Backfeed in a 4-pair context v110

Lennart Yseboodt

Philips Lighting – Research

Backfeed requirement

4-pair backfeed

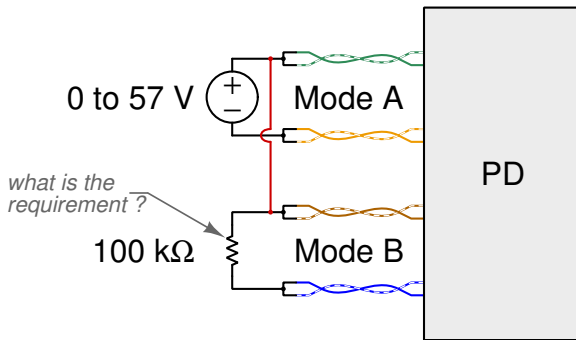
A 4-pair capable PSE typically ties the positive lines together at the PSE end. Even in “2-pair” mode, there are two pairs connected to the positive V_{PSE} . **Does the backfeed requirement still apply? Should it?**

The current text is ambiguous as to whether the condition of two positive pairs is one where backfeeding is limited to V_{bfd} . The intent of the text did not anticipate more than 2 pairs being powered (as this is old text), but it does not clearly exclude it, since connecting one pair of a Mode to a supply rail does not constitute “applying a voltage”.

We must choose to either include or exclude this configuration from the backfeed spec and change the requirement accordingly.

When any voltage in the range of 0 V to $V_{\text{Port_PD-2P max}}$ is applied ~~across the PI at either polarity specified on the conductors of either Mode A or Mode B according to Table 145–20~~ per any of the valid 2-pair configurations with one and only one pair connected to positive V_{PSE} listed in Table 145–20, the voltage and current measured ~~across the PI for~~ on the other Mode with ~~a any 100 kΩ load resistor~~ resistance of 0 to 100 kΩ connected across that other Mode shall not exceed V_{bfd} and I_{bfd} as defined in Table 145–29.

Without strong indication of technical issues caused by 3-pair backfeeding, there is no reason to impose a hard to meet requirement on the PD. As such, we should adopt the “exclusion” baseline on slide 10 and 11.
